Proposition 39

HVAC Retrofit Project

Here are the questions asked during the 2/28 walk-through:

MEADOWLARK CAMPUS
3015 W. Sacramento Street, Acton, Ca. 91351

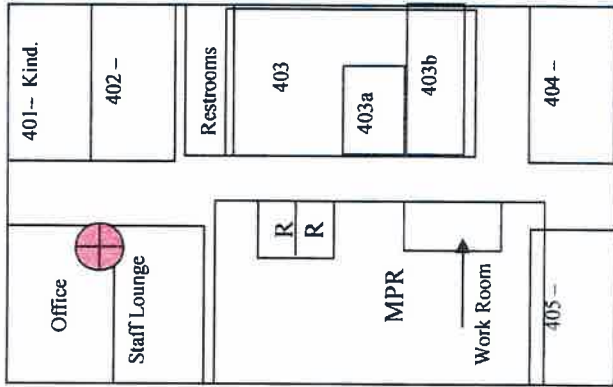
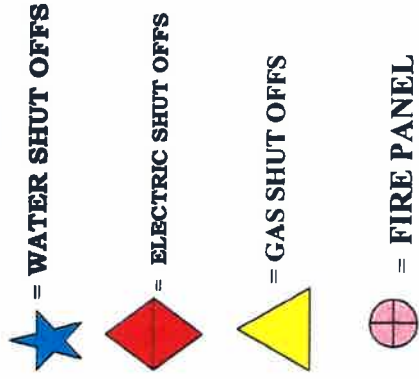
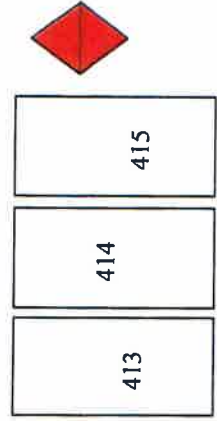
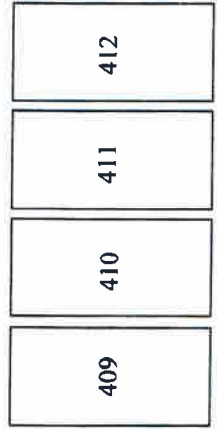
1) What is the budget on this project?

Answer: You are to propose your best price to replace 40 tons of AC and include the High maintenance units. An Aerial image will be provided to identify the High Priority – High Maintenance units.
